8.0 Existing Buildings

8.1 Listed Building Workhouse

Workhouse AOV – North Facade 2nd Floor Staircase Window

Approved 2019 Workhouse North elevation

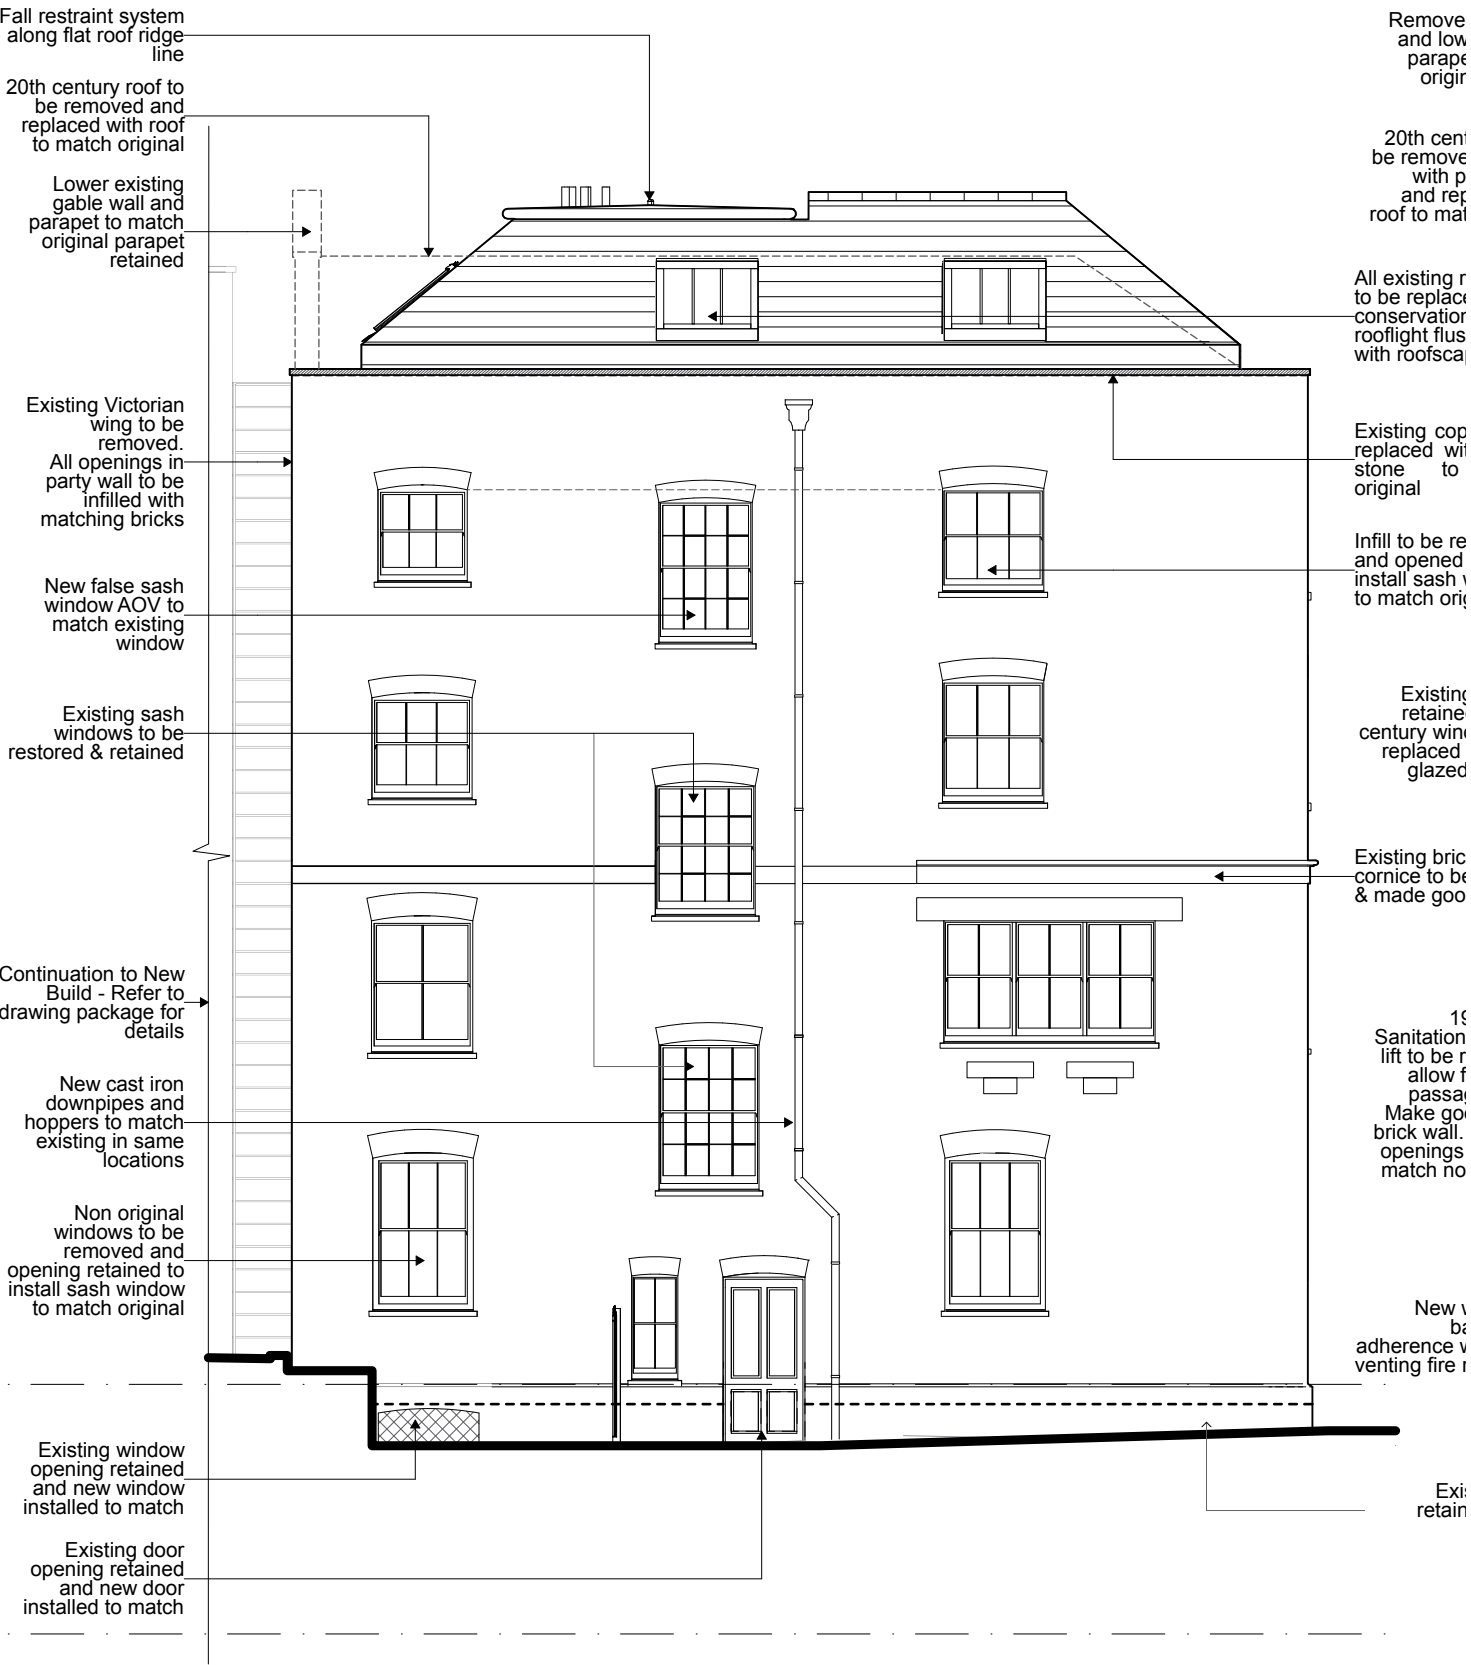
Replacement air will be provided by a 1m² AOV conforming to BS EN 12101-2, located at the window on the top storey of the stair. This has been approved with the previous 2019 application, see drawing below showing approved North Elevation.

Elizabeth Martin Camden Conservation Officer attended a site visit in early 2019 and confirmed the sash windows to the staircase can be replaced like for like. Retaining or replacing the sash window, no AOV exists that conforms and meet the BS standards EN12101-2. This option was not developed any further.

Option 3 – Mock Sash Window with Magnet Lock Actuator

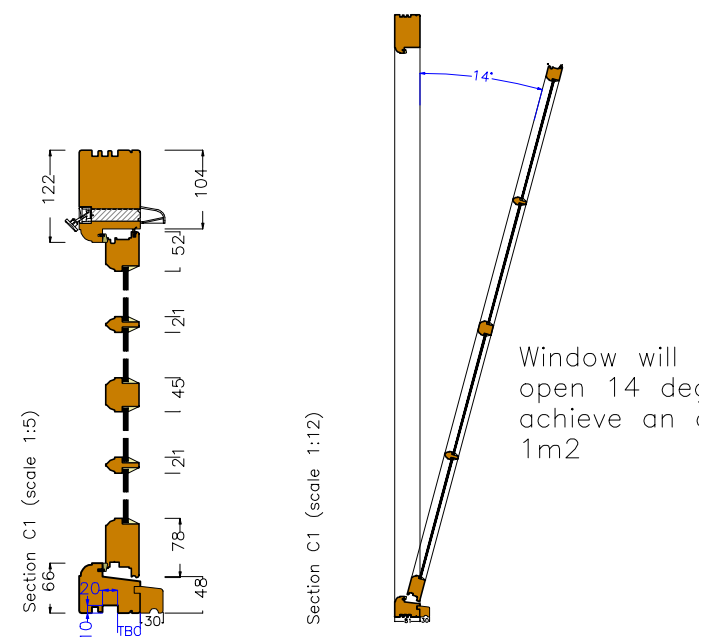
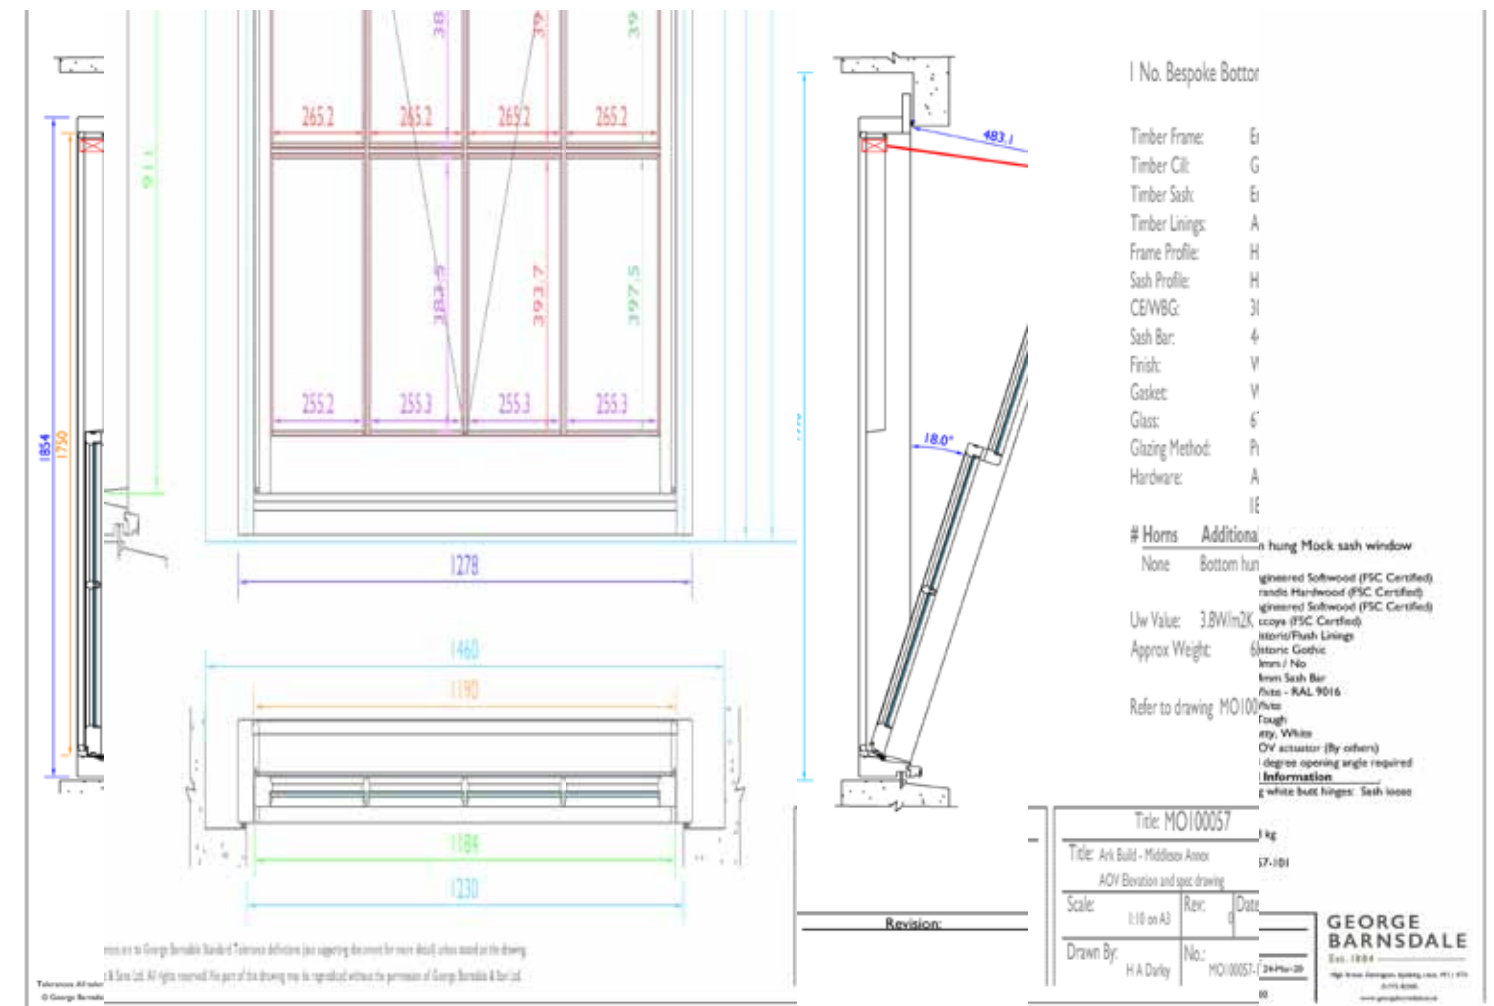
Once the fire alarm was triggered, the magnets holding the window at the top would release, tilting the window forward on a chain at an angle of 14 degrees to provide the correct square metres of smoke ventilation.

The drawing above by the manufacturer was rejected, due to the fact it looked like a casement window and did not resemble the sash windows below. Subsequently, we asked the manufacturer to provide a window that was truly a dummy sash window, except the window opened like a bottom hung basement window. This would then provide adequate smoke ventilation.

We agreed with the manufacturer that this was a bespoke solution and asked for the manufacturer to provide the necessary certificates that this would meet BS standards EN12101-2. The manufacturer then informed the design team that due to the bespoke nature of the window, the actuator, that this approach had not been tested together and would not meet the fire requirements.

We have looked into fire testing and been advised that we would have to undertake a bespoke fire test and to allow for a budget of £30,000 - £50,000 to undertake the fire, maintenance testing etc. Secondly, if we could afford to undertake the testing, the manufacturer and tester have confirmed that after 3 - 6 months of testing they cannot guarantee this setup approach will pass.

A new design was developed that met the visual requirements for the listed building.

The drawing opposite BPD-LDW-WH-ZZ-DR-A-253012 AOV WINDOW DETAIL.

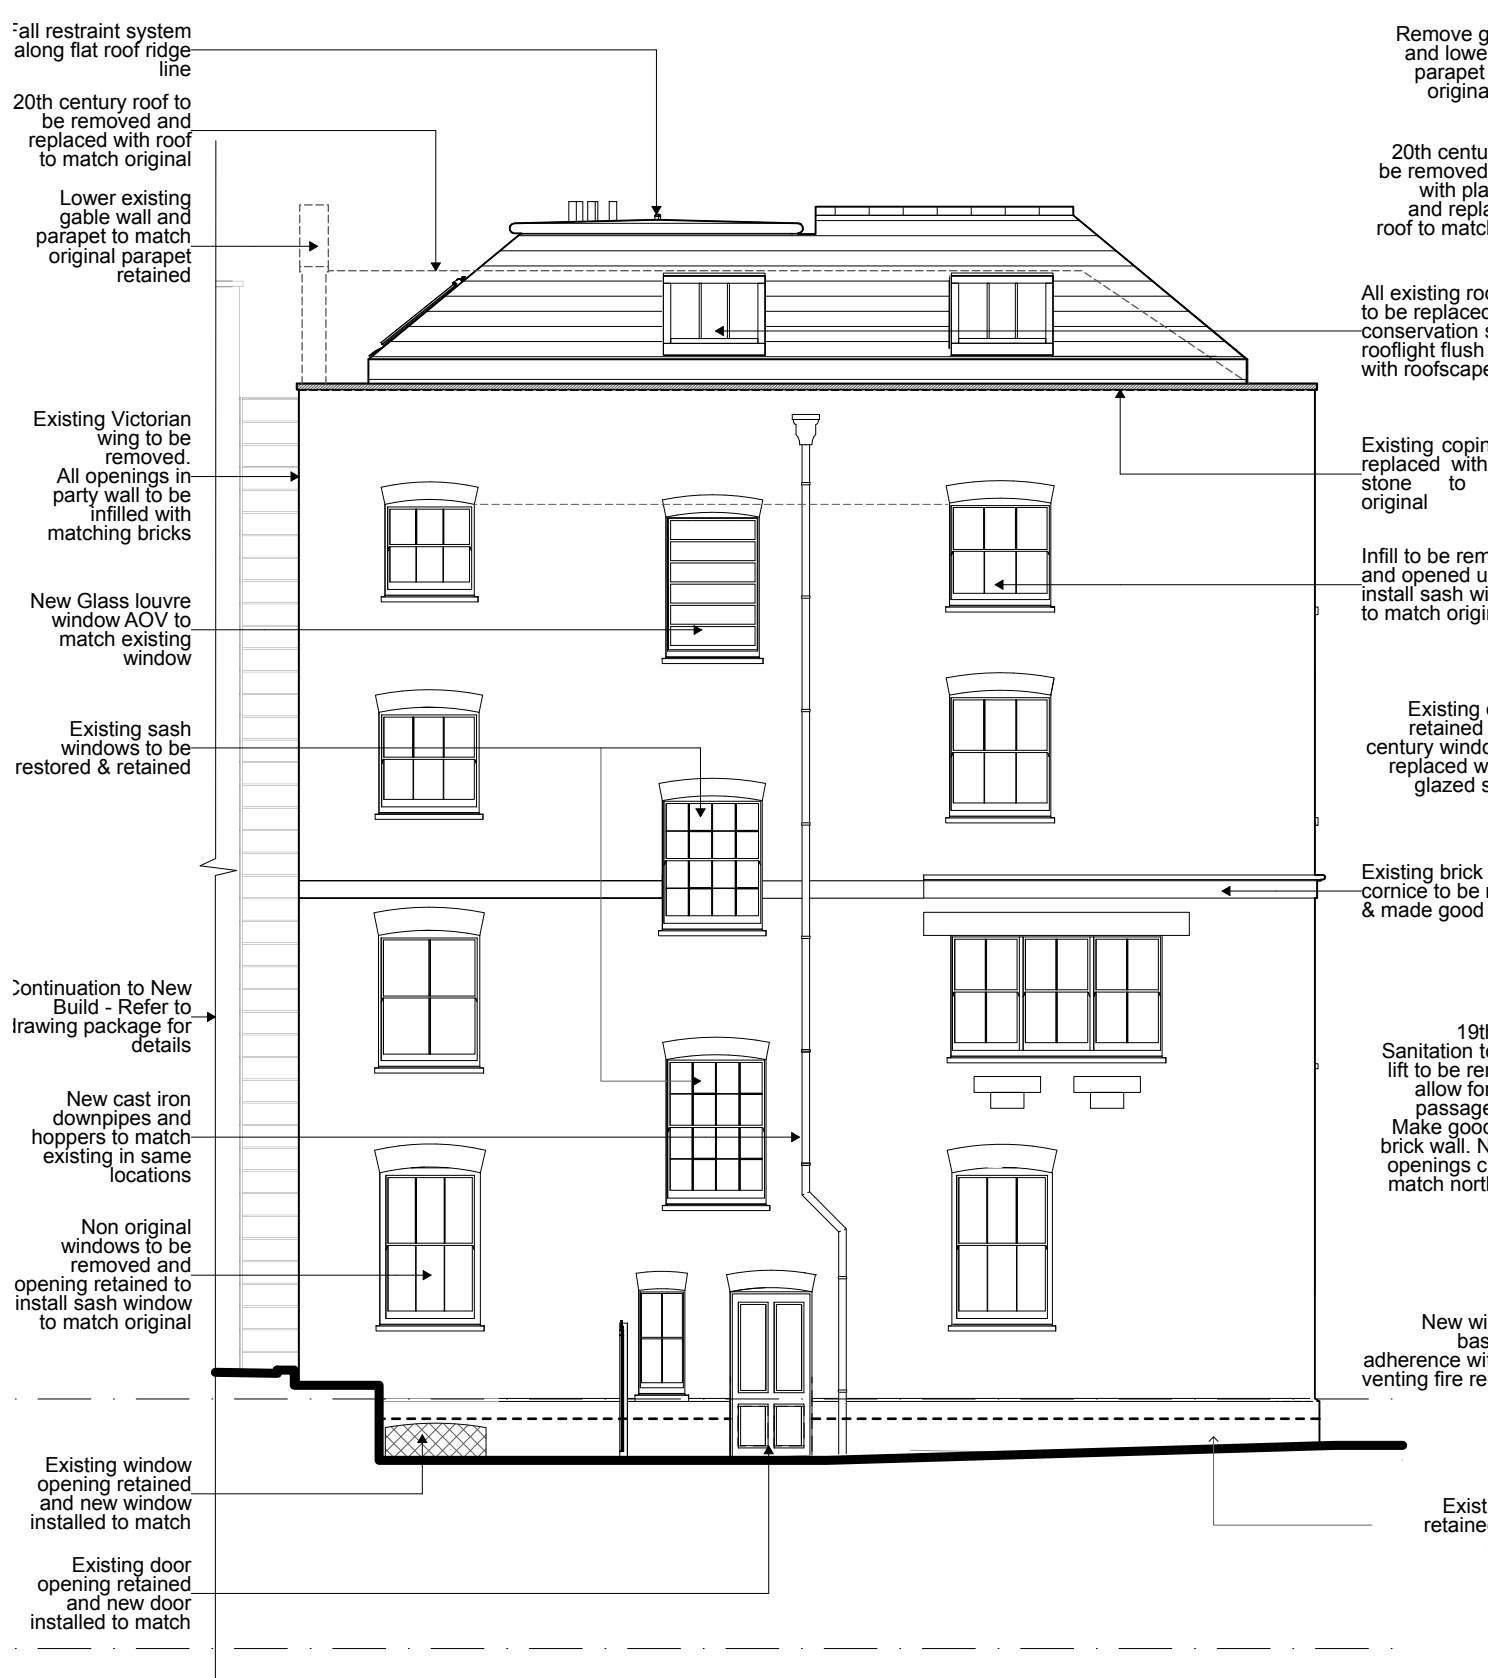
This shows a glass louvered AOV SHEVTEC system that is fully compliant and meets the requirements for EN12101-2.

A revised elevation called E_LB_03-04 Listed Building Proposed Elevation 03 & 04 Rev G has been submitted showing the alternative proposal using a glass louvered window. This shows the full North elevation.

The glass louvers will also match the louvered glass panels to the new proposed lift tower east of the workhouse. The simplicity of the glass louvers we believe will be less invasive than installing a metal or UPVC window system to this location.

Proposed AOV Glazed louvre Window

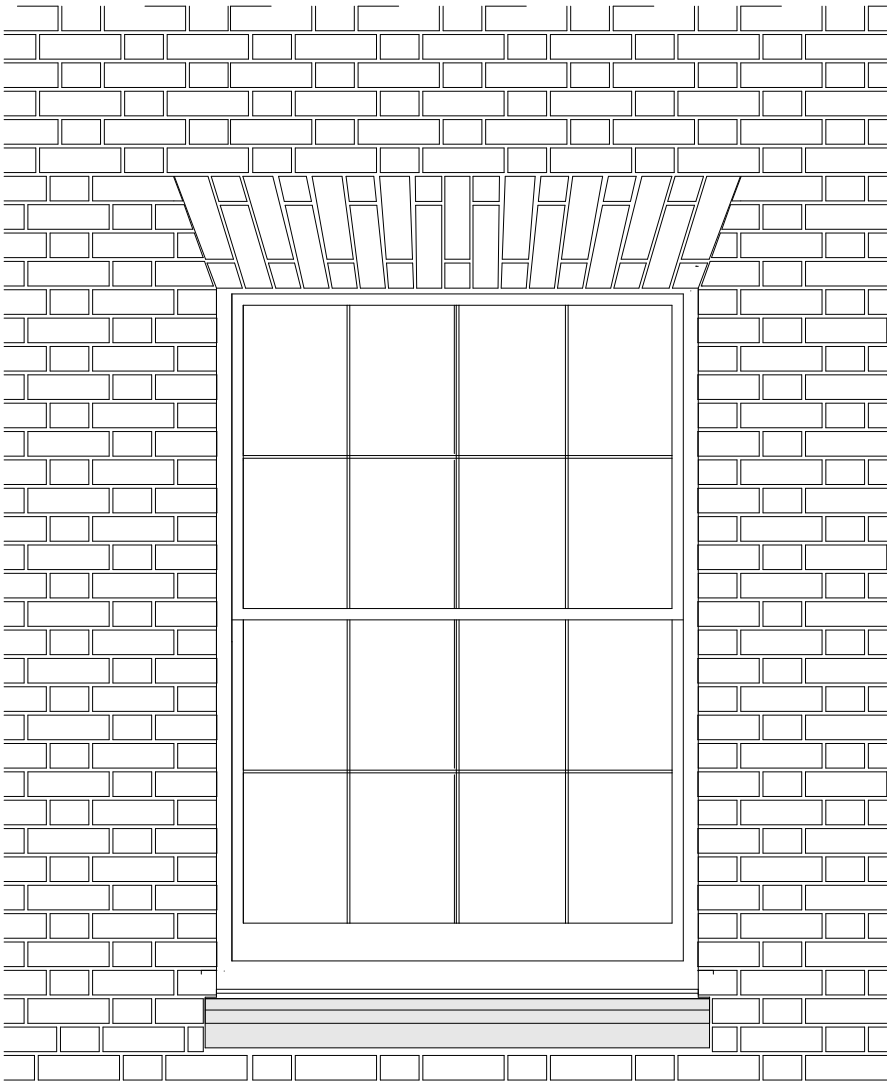
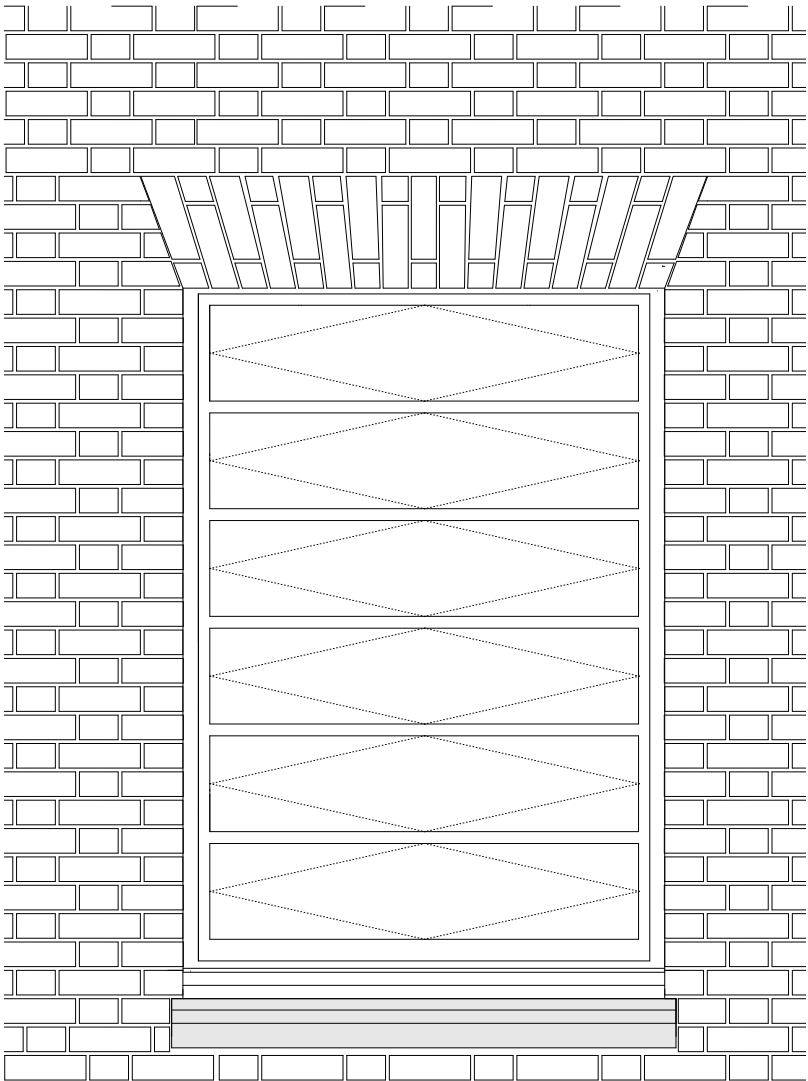
Further discussions with the conservation officer regarding the colour of the louvre frame either as black or white. The design team preferred choice is a white frame. Visuals have been shown for both approaches.
